IREDELL COUNTY HEALTH DEPARTMENT

IMPROVEMENT PERMIT / AUTHORIZATION TO CONSTRUCT / OPERATION PERMIT / EXISTING SYSTEM INSPECTION

PERMIT# 100780 PIN# 4765 93 7795.5 DATE 6-19-01

LOCATION HWY 64E, @ TRIPLE OAKS RD, AT END OF CUL-DE-SAC

INITIAL SITE SKETCH 225'.10'

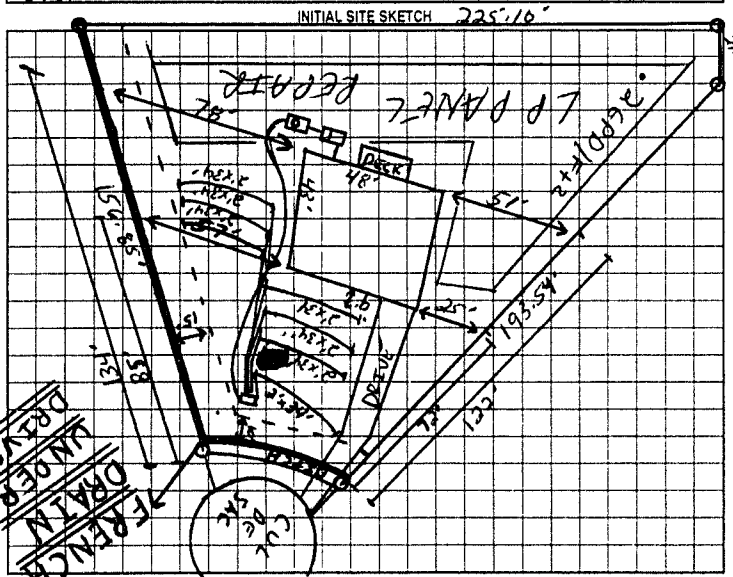
Comments/Conditions: ① USE Pressure Manifold ② MAINTAIN SETBACKS, ESPECIALLY OFF FRENCH DRAIN ③ INSTALL LINES ON CONTOUR ④ INSTALL FRENCH DRAIN 48" DEEP.

1"=50' AS BUILT SKETCH

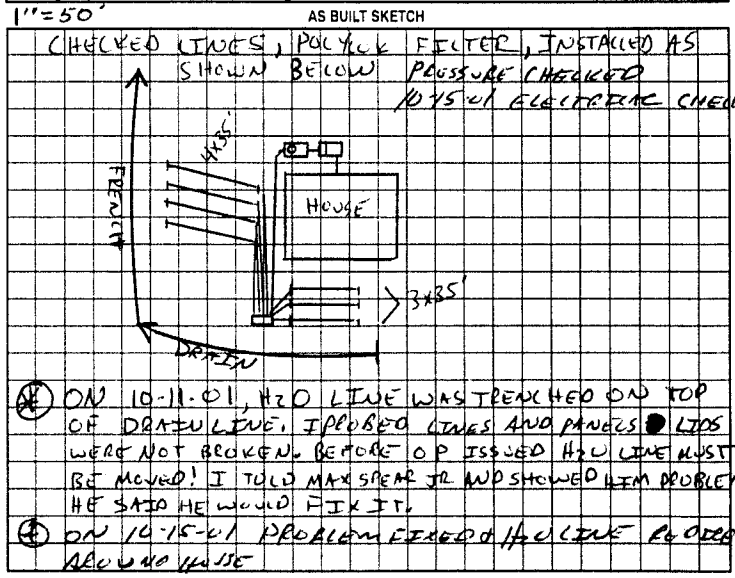
Comments/Conditions: FRENCH DRAIN INSTALLED & CHECKED DUE TO H2O LINE & ELECTRICAL LINE, FRENCH DRAIN MOVED DOWN A LITTLE SO I CAN ONLY GET 3 LINES ABOVE & ALL TO THE SIDE DUE TO SETBACKS

④ ON 10-11-01, H2O LINE WAS TRENCHED ON TOP OF DRAIN LINE. I PROBED LINES AND PANELS ● LIDS WERE NOT BROKEN. BEFORE OP ISSUED H2O LINE MUST BE MOVED! I TOLD MAX SPEAR JR AND SHOWED HIM PROBLEM. HE SAID HE WOULD FIX IT.

④ ON 10-15-01 PROBLEM FIXED H2O LINE RELOCATED AROUND HOUSE
